SAN ANTONIO WATER SYSTEM
ANDERSON PUMP STATION IMPROVEMENTS
SAWS JOB NO. 07-6007
SOLICITATION NO. B-11-002-DD

ADDENDUM NO. 2
May 2, 2011

B&V PROJECT NO. 161472
 SAWS JOB NO. 07-6007
 E-11 SHEET 46 OF 102

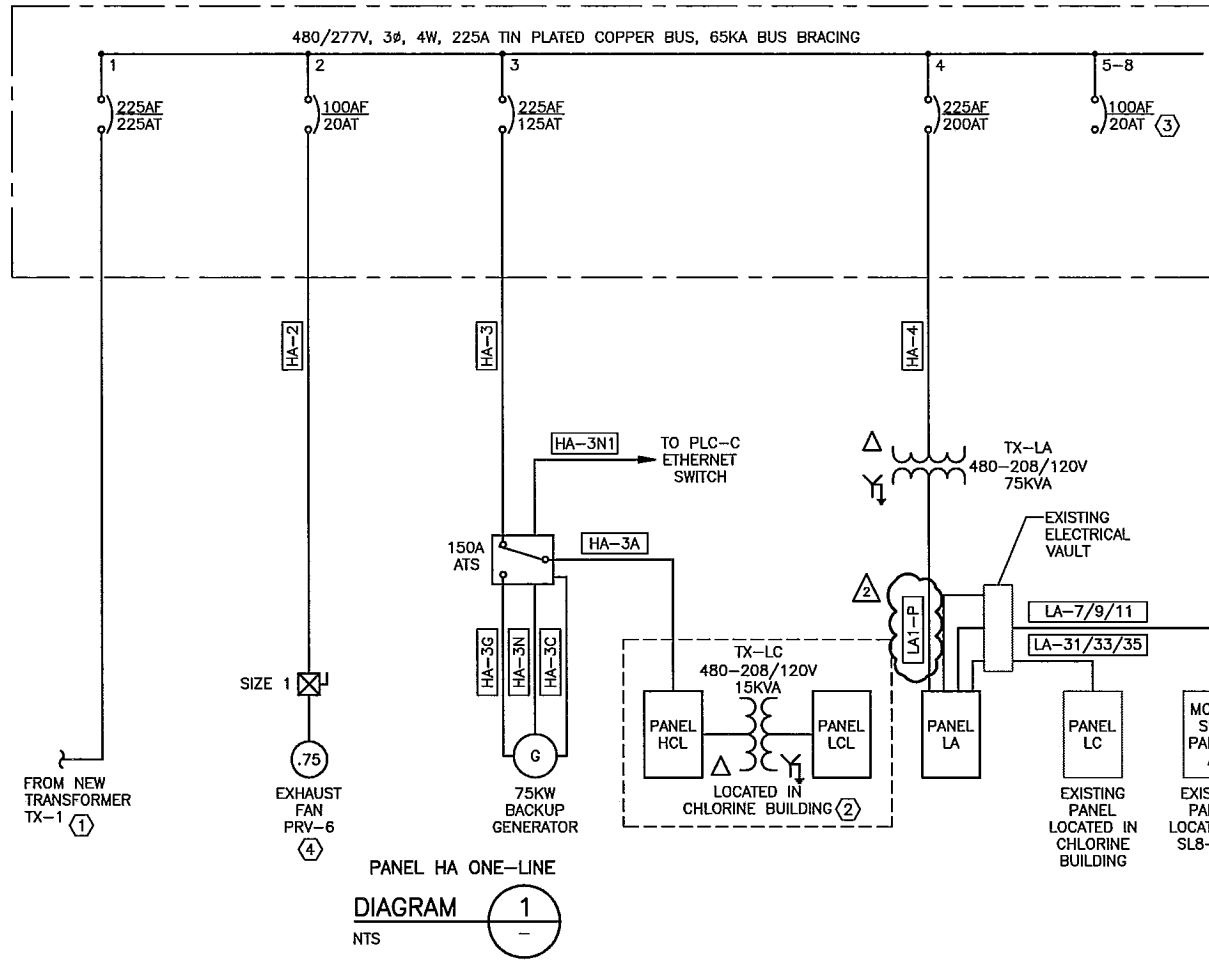
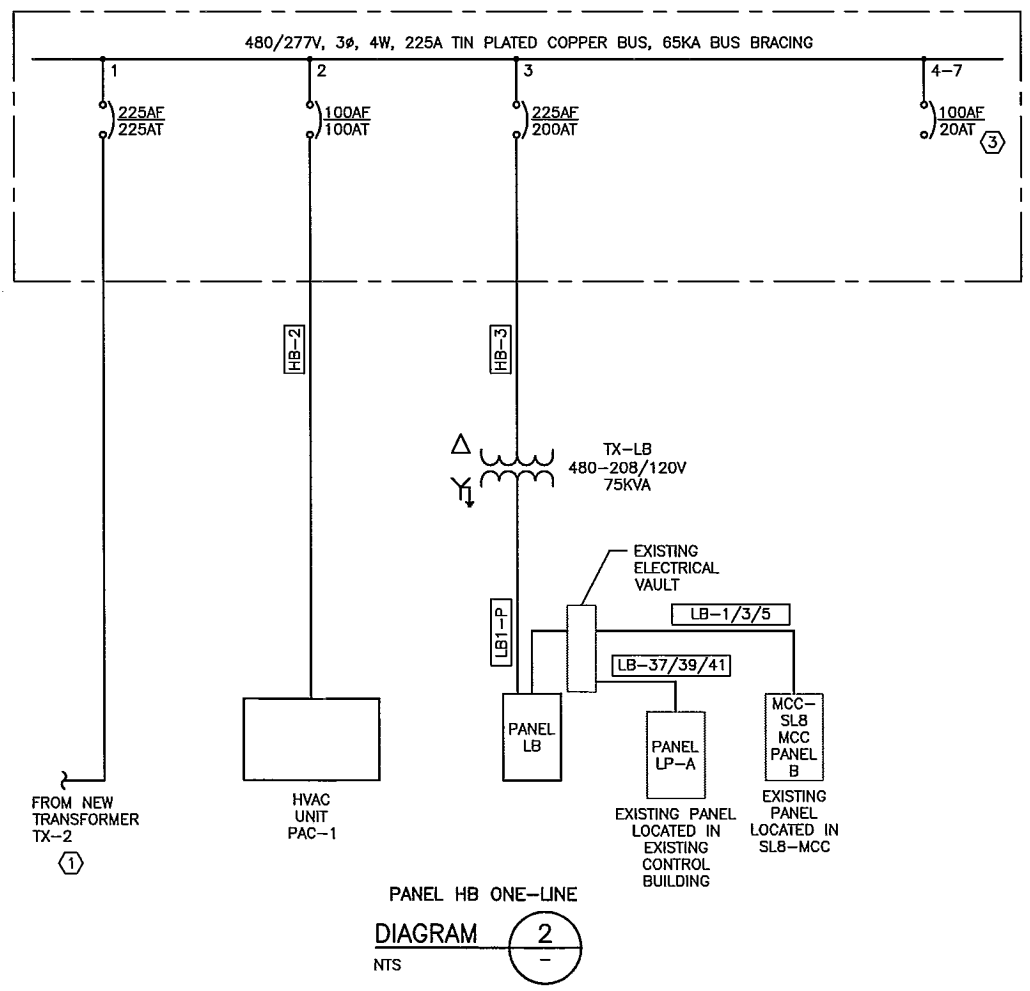
60. Reference: Sheet E-5. Is #1 in duct bank H 2"? RESPONSE: Yes. See change to Sheet E-5 included with this addendum.
61. Reference: Sheet E-11. Are panels LA and LB main circuit breaker? If not, how are these panels protected. RESPONSE: Panels have 200A main circuit breakers, as shown on the panelboard schedule on Sheet E-11.

62. Reference: Sheet E-11. Transformer TX-LA and LB is fed from a 200AT; a standard size of 125A would be required to provide the required protection. RESPONSE: 200AT is appropriate based on NEC Table 450.3(B).

63. Reference: Sheet E-11. The feeder to panels LA and LB are not shown. RESPONSE: Acknowledged. See changes to Sheet E-11 included with this addendum.

64. Reference: Sheet E-11. Is HA-3G really HA-3A? RESPONSE: No. HA-3G is a separate circuit. See changes to Sheet E-11 included with this addendum.
65. Reference: Sheet E-11. It appears on the schedule that some circuits are lacking grounds and others are full size grounds. Is a standard size ground per NEC 250-95 sufficient? Also several circuits appear to be improperly marked HB in lieu of HA. RESPONSE: Provide full size grounds. See changes to Sheet E-11 included with this addendum. These changes will clarify which circuits require neutrals.

12. Sheet E-11 (46 of 108)
 - a. Replace Sheet E-11 with new Sheet E-11 that is included with this addendum. Changes are shown in clouded areas.
13. Sheet E-13 (48 of 108)
